ORCAS MOON PROJECT
SEP16-02269

ORCAS MOON COTTAGES PRELIMINARY PLAT / IDP

File: ORCAS MOON COTTAGES/SUBDIVISION/BUFFER MODIFICATION
 SUB16-02267

Figure 1 – Tree #20709 and 20736 LOD's in green, location of the unmarked cedar and location of the high risk Douglas fir tree

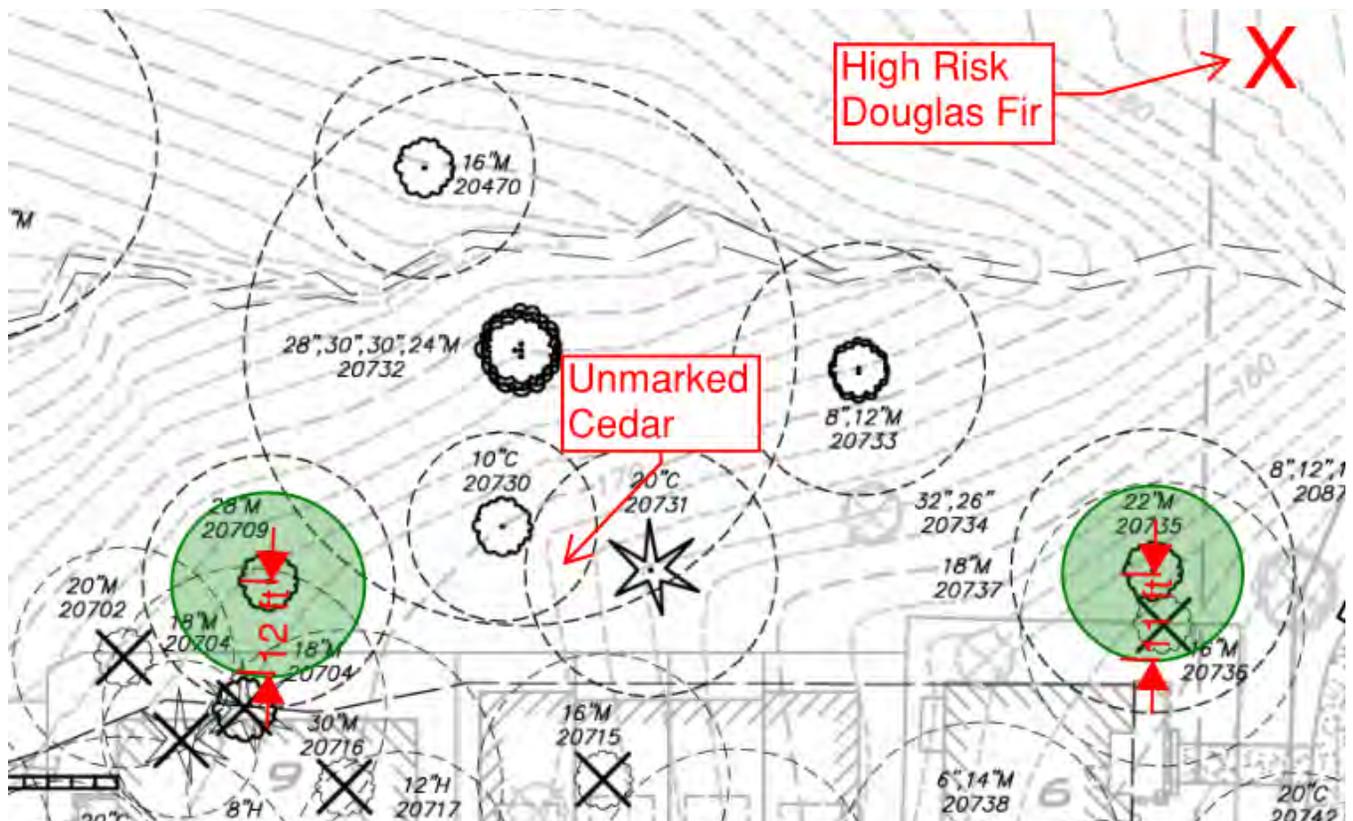
The arborist report is fairly accurate although I'd like to note the following:

- There are a handful of trees where I downgraded the health and/or structure from what the consulting arborist had determined in the arborist report. Doing so resulted in a few trees being non-viable. All other downgraded trees did not result in a change in their retention value.
- There is a large (~24" dbh) Douglas fir on the site that is actively failing and could be considered a high risk if people are entering the site. The approximate location is marked as a large red X in Figure 1.
- I found one significant Western red-cedar located approximately 5' north of tree #20731 that was not included in the tree inventory. It is good health (rating of '1') and structural condition (rating of '2') with a slight sweep and co-dominant stems that measure 5.3" and 7.6".
- Tree #21022 in the tree inventory table is not shown on the site maps. It is located near tree #21021.

1. The proposed development shows that excavation and construction will occur within the drip lines of tree #1033, 1034, 1038, 1039, A, 1019, 20495. It would be prudent for the applicant to have their arborist complete a report to evaluate the impacts of construction on these trees and to provide LOD's.
2. Both tree #20735 and #20709 are big leaf maples proposed to be retained. Based on the plans, fill will be added within the LOD's of both trees. Big leaf maples are intolerant of fill. The site plans could be altered to avoid this. See Figure 1.
3. If culverts are replaced additional trees will need to be added to the arborist report.
4. Remove the leaning Douglas fir prior to work occurring on the site. See Figure 1.

An updated arborist report and tree retention plan shall be submitted with the Land Surface Modification permit.

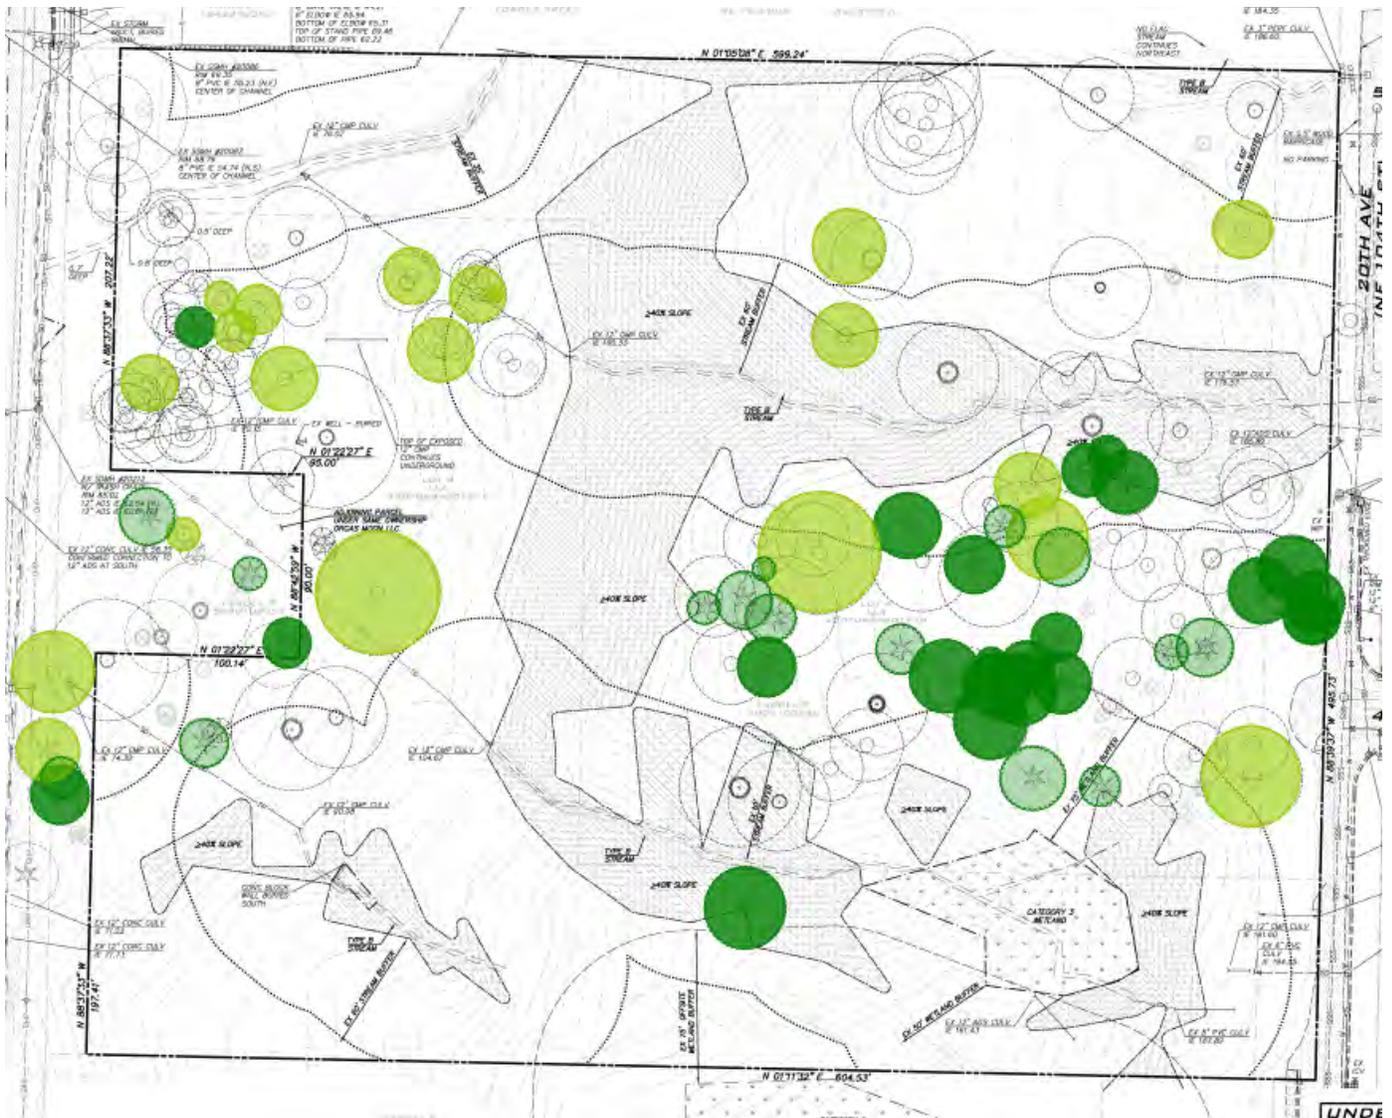
From an urban forestry perspective, the most desirable trees surveyed are located in the area where the majority of the construction will occur. Figure 1 shows the best trees based on health and structural condition. The darkest green circles indicate conifer species in 'excellent' condition while the lighter shade of this color shows conifer species in 'good' condition. Chartreuse green indicates deciduous trees in 'excellent' condition. In addition, this area is also relatively free of invasive species and has a healthy native understory shrub layer consisting of sword fern, salmonberry, Indian plum, trailing blackberry, Oregon grape, red huckleberry, thimbleberry as well as others. Although there are many trees in the eastern portion of the property with good health and structural condition, a good majority of them will be removed with the development as they do not qualify as 'high retention value' trees per Kirkland Zoning Code (KZC) 95.10(13). Figure 2 shows the retention value of all surveyed trees.

In contrast, the eastern portion of the property is comprised of smaller deciduous species with only a few conifers in 'good-excellent' condition (Figure 1). This area is also heavily inundated with invasive species such as Himalayan blackberry, English ivy, Japanese knotweed, red canary grass, and a very large climbing grape vine. There are some native understory shrub species

Street and Pedestrian Improvement Conditions:

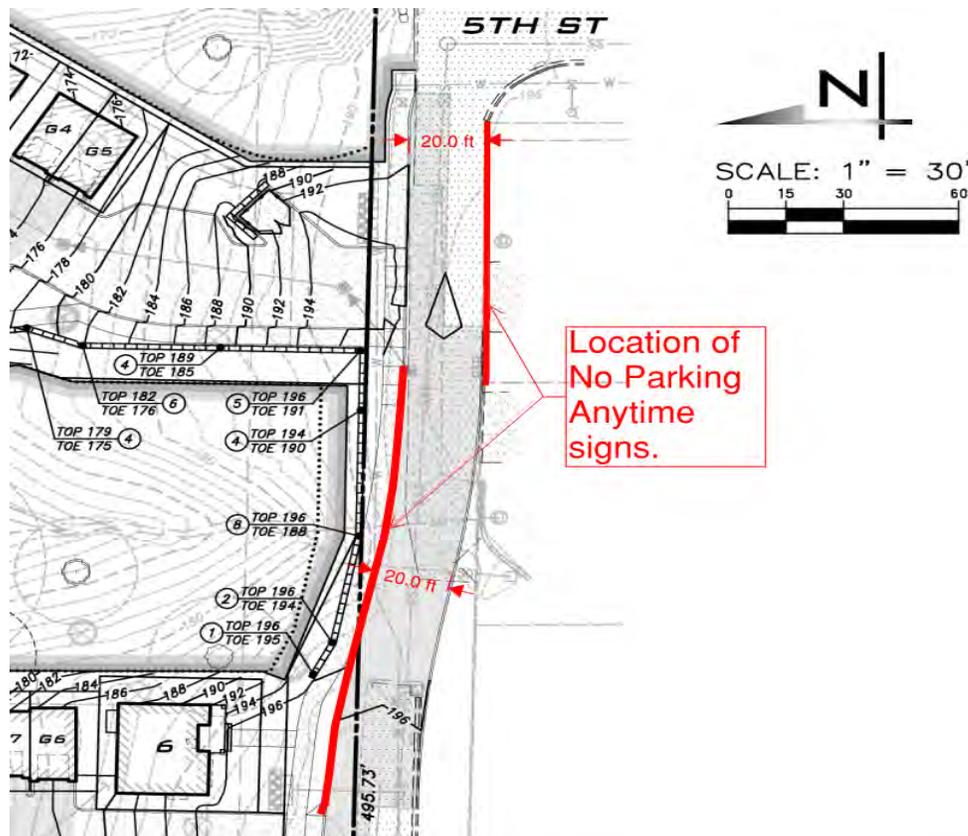
1. The subject property abuts Forbes Creek Drive and 20th Avenue. These streets are Collector and Neighborhood Access type streets, respectively. Zoning Code sections 110.10 and 110.25 require the applicant to make half-street improvements in rights-of-way abutting the subject property. Section 110.30-110.50 establishes that this street must be improved with the following:

- A. Forbes Creek Drive Improvements:
 - Due to a Lot Line Alteration the Project does not have any frontage on Forbes Creek Drive and therefore no right-of-way improvements are required.

- B. 20th Avenue Improvements:
 - Install Type A curb and gutter 8 feet north of the south property line to face of curb (match existing curb line to the west). Provide a minimum of 20 feet of paving adjacent to the new curb (applies to areas where there is currently no paved street section along 20th Avenue). On the east end of the project set the new Type A curb 24 feet from the existing curb and extend to the east property line.

- Behind the curb provide a 4.5 feet landscape strip with street trees 30 foot on center and a 5 foot wide sidewalk.
 - Dedicate a minimum of 20 feet of right-of-way along the project frontage starting at the west property line for approximately 290 feet then tapering back to the existing right-of-way line on a straight line taper for 50 feet; dedication to encompass all the required improvements.

- Eradicate Knotweed via injection methods prior to installing any frontage improvements.
 - These improvements may need to be modified pending any unforeseen environmental analysis. Attachment 2 shows the modified frontage improvements based on the environmental analysis to date and is approved by the Public Works Department.
